**PSE&G** Public Service  
Electric and Gas  
Company

August 20, 1984

HOPE CREEK GENERATING STATION  
DOCKET NO. 50-354  
DRAFT SAFETY EVALUATION REPORT  
OPEN ITEM STATUS

Attachment 1 is a current list which provides a status of the open items identified in Section 1.7 of the Draft Safety Evaluation Report (SER). Items identified as "complete" are those for which PSE&G has provided responses and no confirmation of status has been received from the staff. We will consider these items closed unless notified otherwise. In order to permit timely resolution of items identified as "complete" which may not be resolved to the staff's satisfaction, please provide a specific description of the issue which remains to be resolved.

FIGURE ~~220.21-54~~ 220.21-54  
 RESPONSE SPECTRA COMPARISON,  
 INTAKE STRUCTURE AT ELEV. 135'-0".  
 VERTICAL, OBE, 2% DAMPING

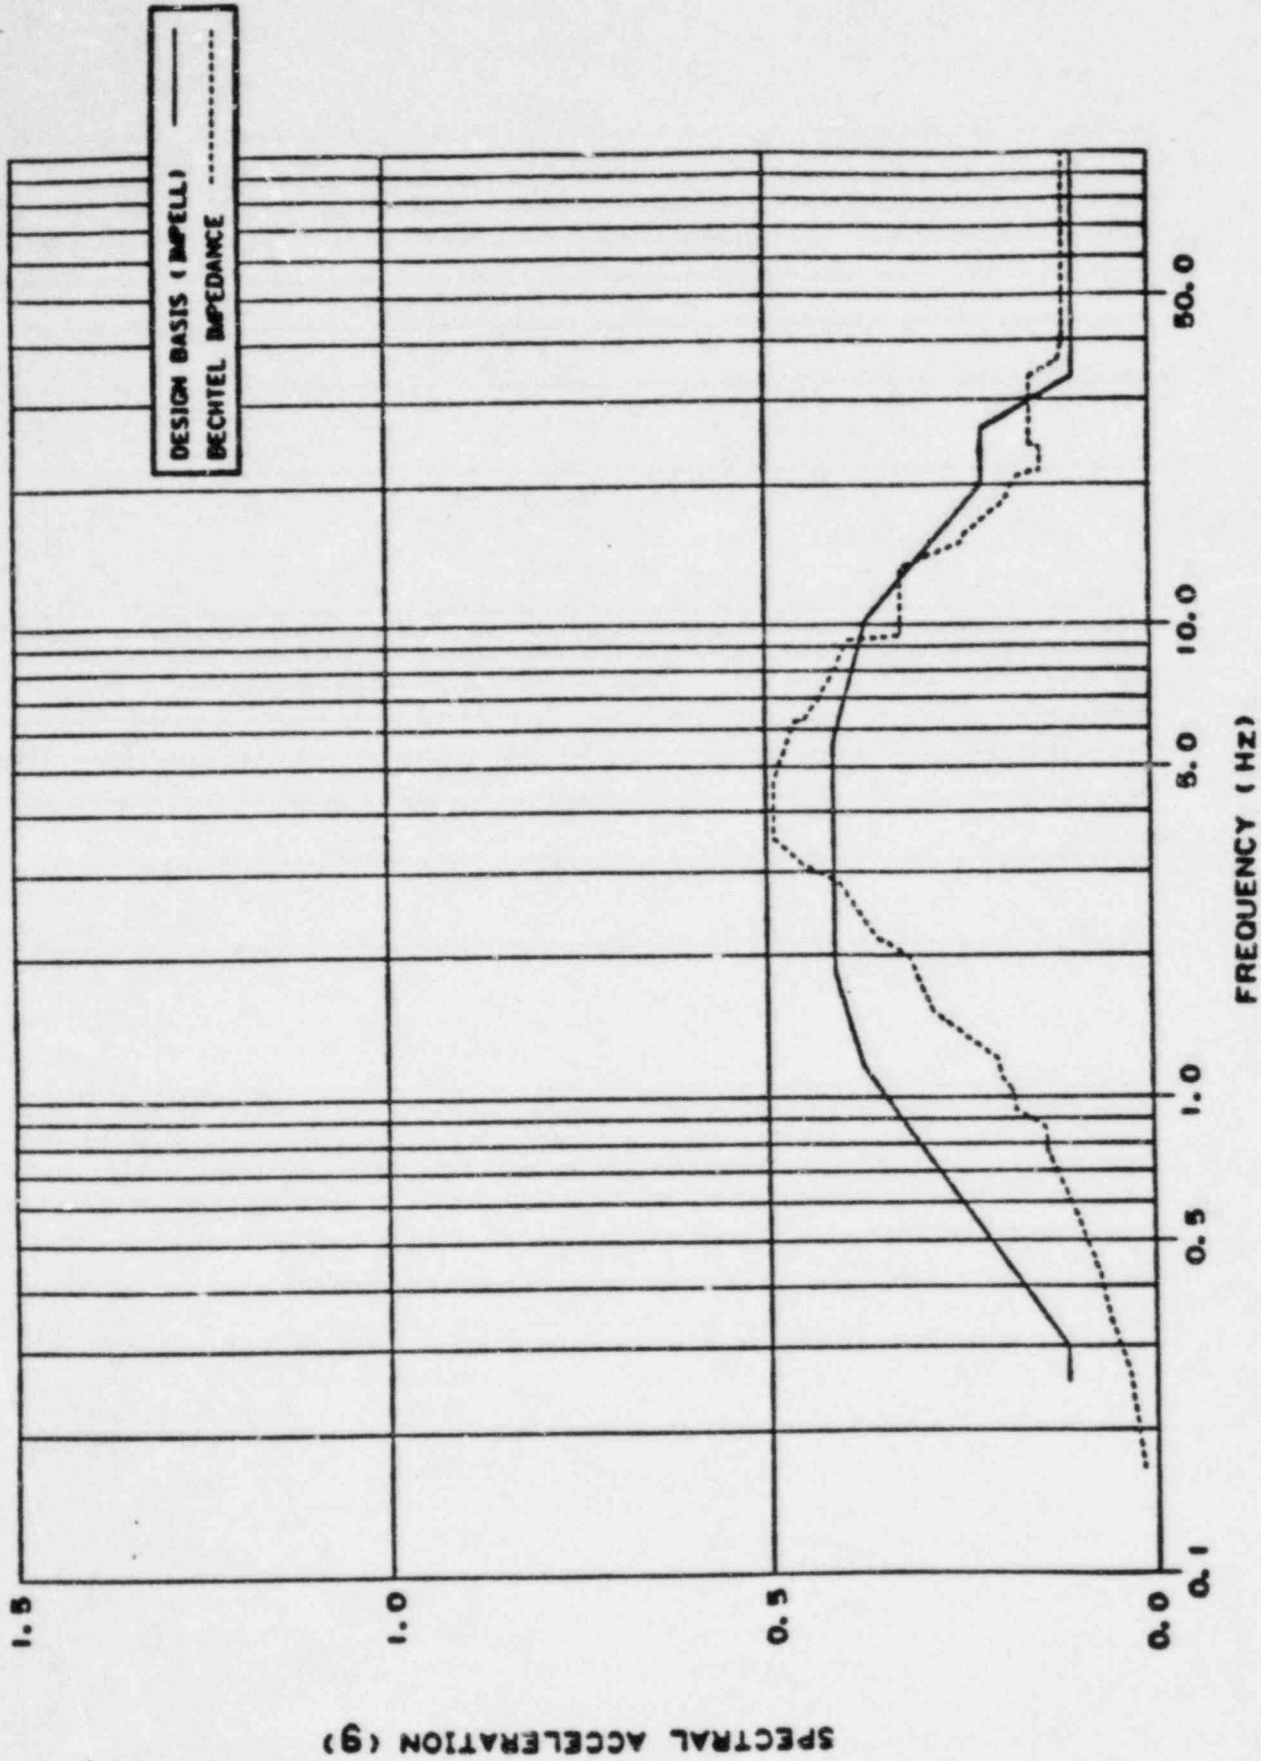
Figures 220.21-1 through 220.21-54 show a comparison of the 2 percent damping response spectra obtained from the design basis finite element and the impedance analyses for the reactor building, auxiliary building and the service water intake structure (SWIS).

¶ For the reactor and auxiliary buildings, the peak spectral accelerations obtained from the impedance analysis are generally lower than those obtained from the design basis analysis. However, the impedance analysis response spectra are not completely enveloped by those obtained from the design basis analysis, especially in the frequency range from 1.0 to 3.5 Hz. Also, there are some local exceedances in the higher frequency range, as shown in Figures 220.21-1 through 220.21-36. ¶ For the SWIS (Figures 220.21-37 through 220.21-54), the impedance analysis response spectra are generally enveloped by those obtained from the design basis analysis at elevation 114.0 feet. For other elevations, the impedance analysis spectral accelerations exceed the design basis spectral accelerations in some frequency ranges. These ranges vary approximately between 1.5 and 10.0 Hz.

In all cases, the items reviewed during these sampling studies can accommodate the loads resulting from the impedance analysis. Therefore, the impedance analysis results have no impact on the plant design.

REACTOR VESSEL PRESSURE  
VS TIME AFTER BREAK  
(MAXIMUM MAIN STEAM LINE BREAK  
OUTSIDE PRIMARY CONTAINMENT,  
FAILURE OF CHANNEL A DC SOURCE)  
FIGURE 6.3-57

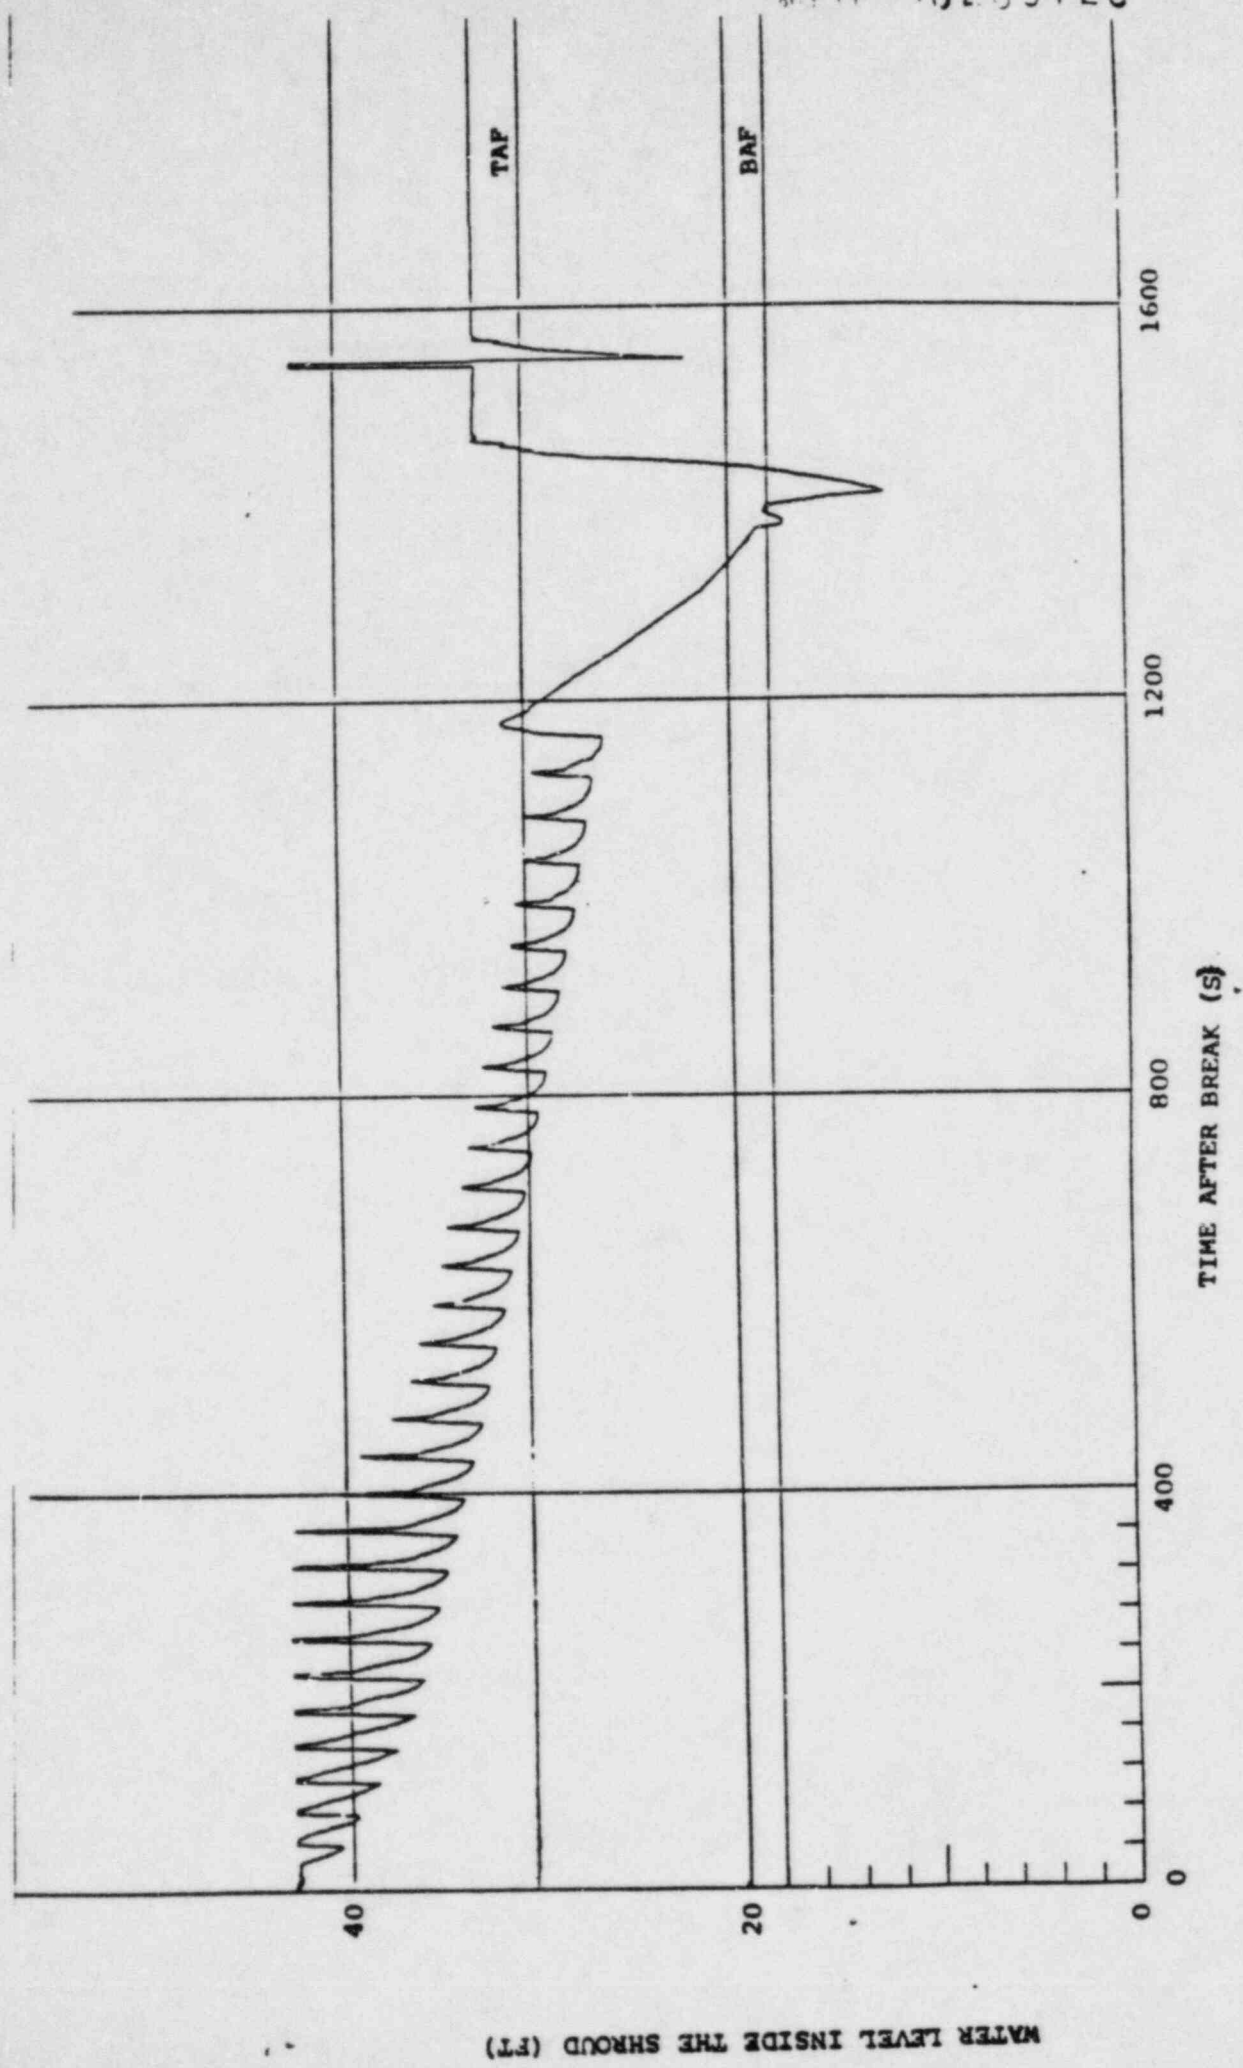
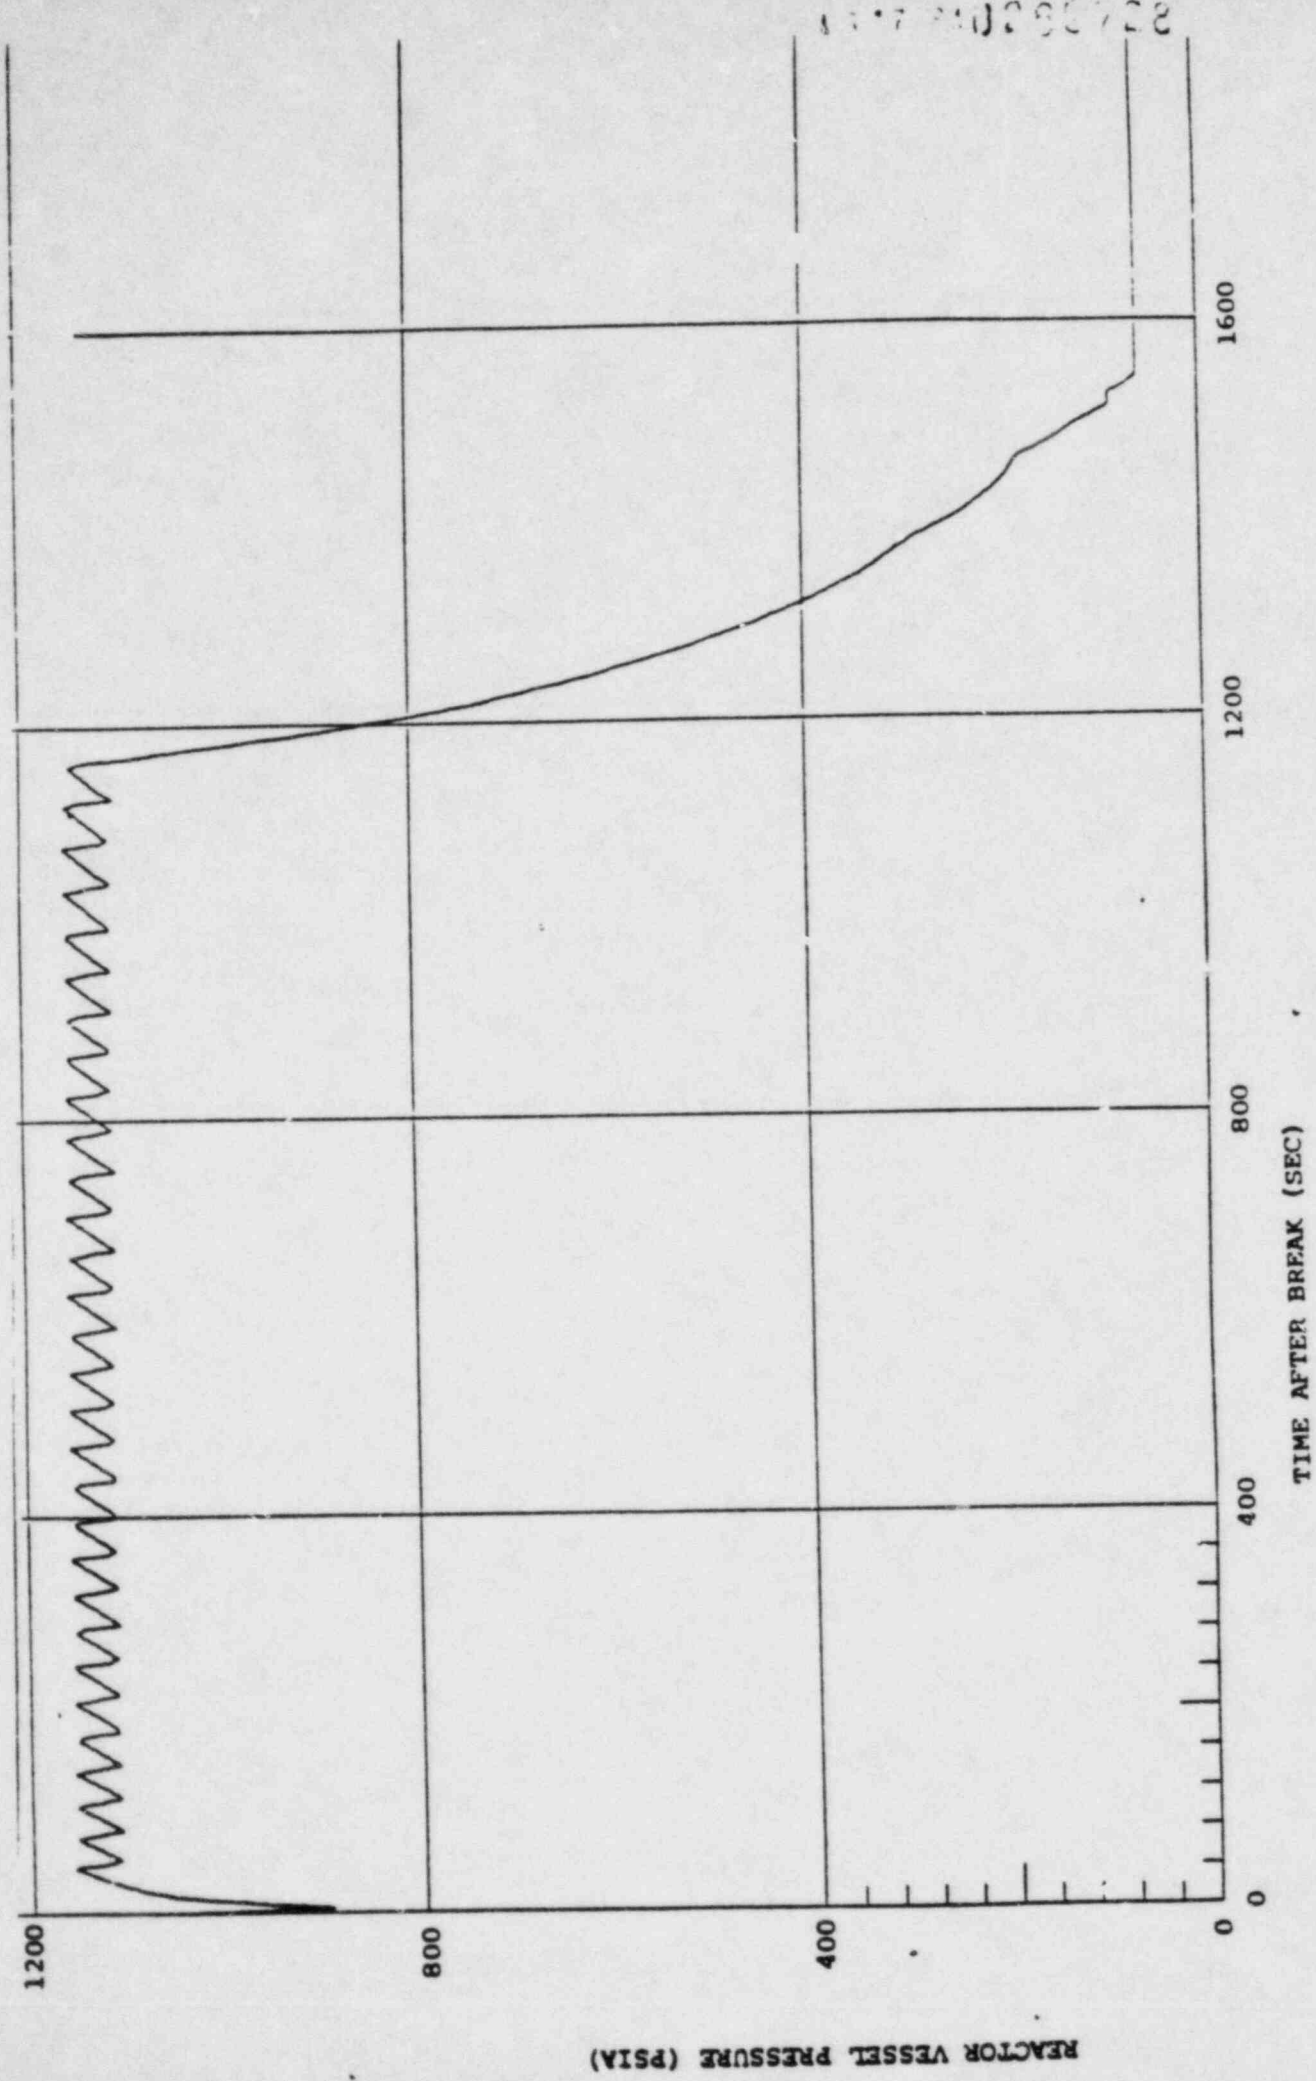
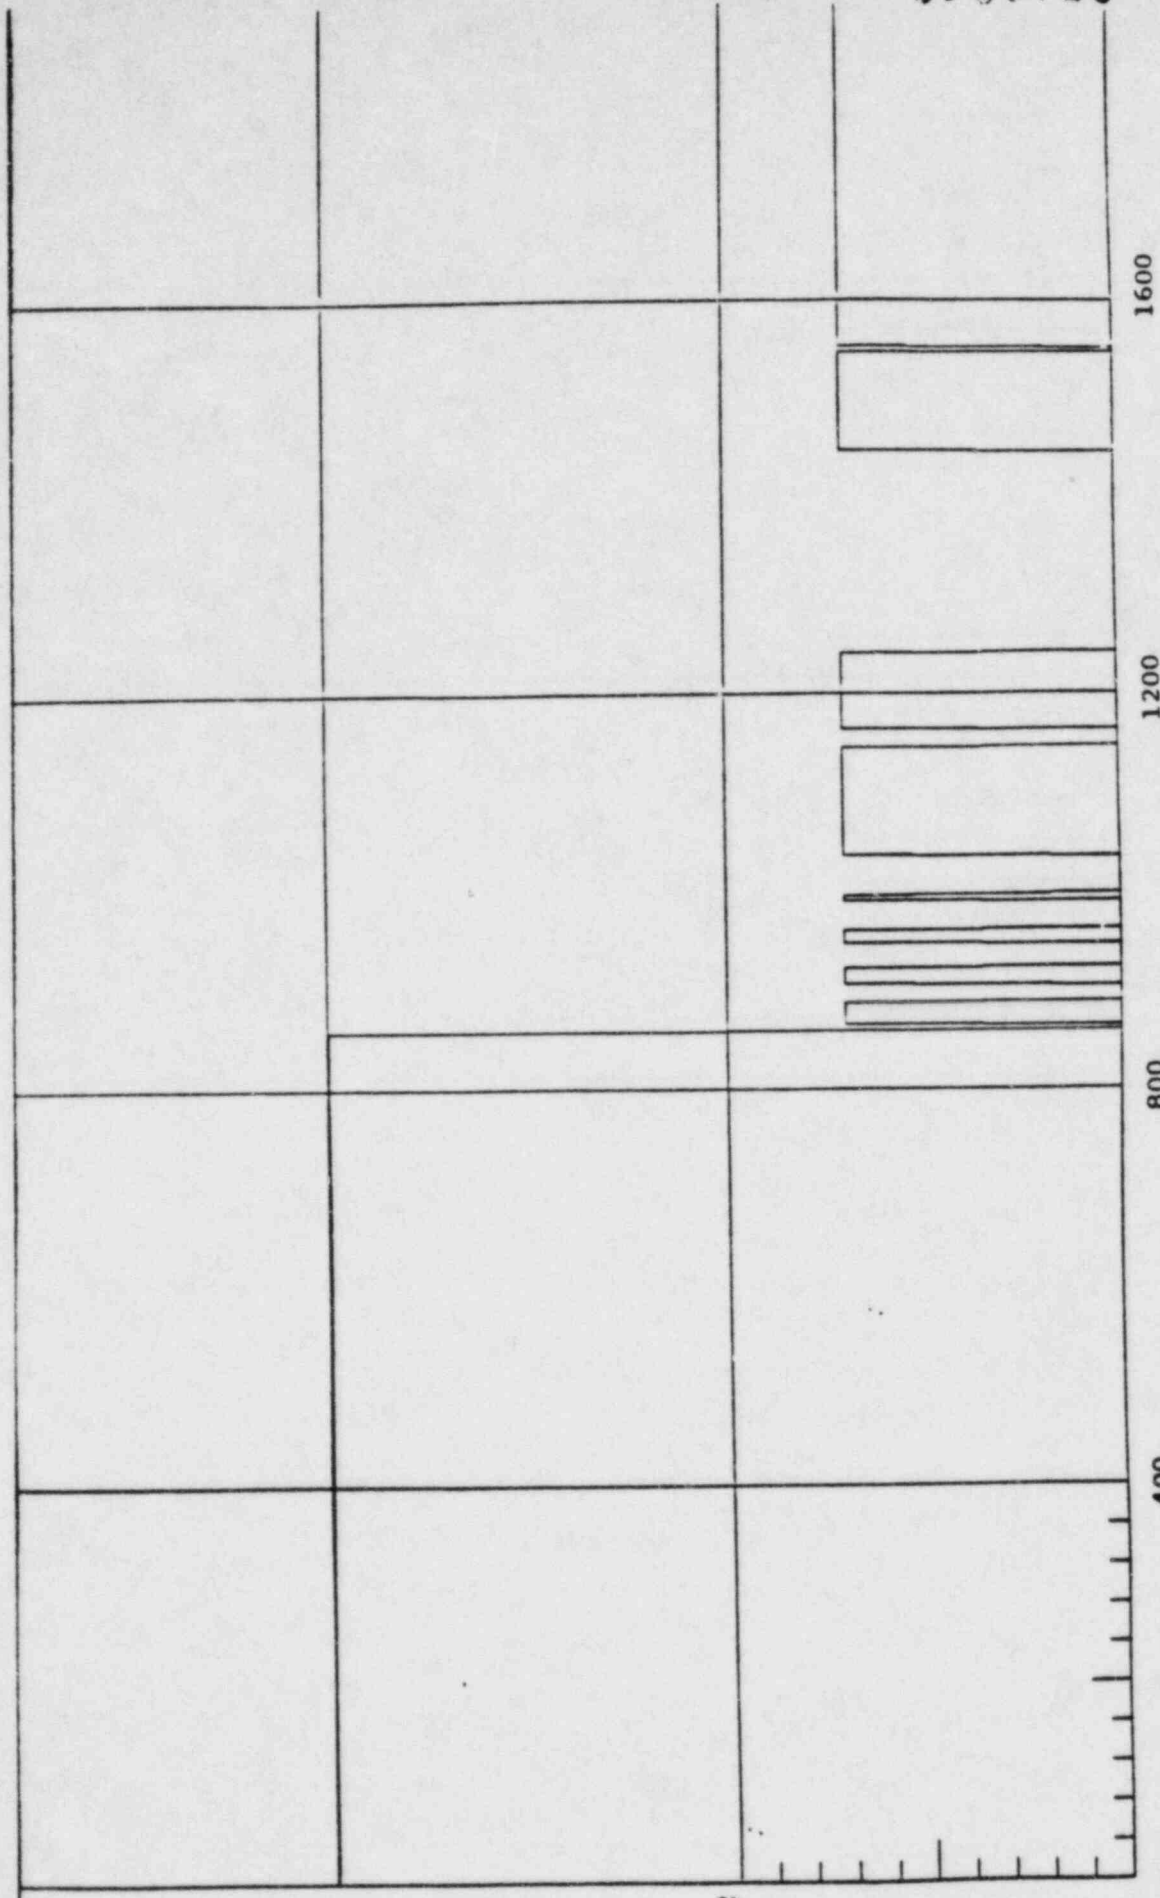
*\* Replace with attached figure*
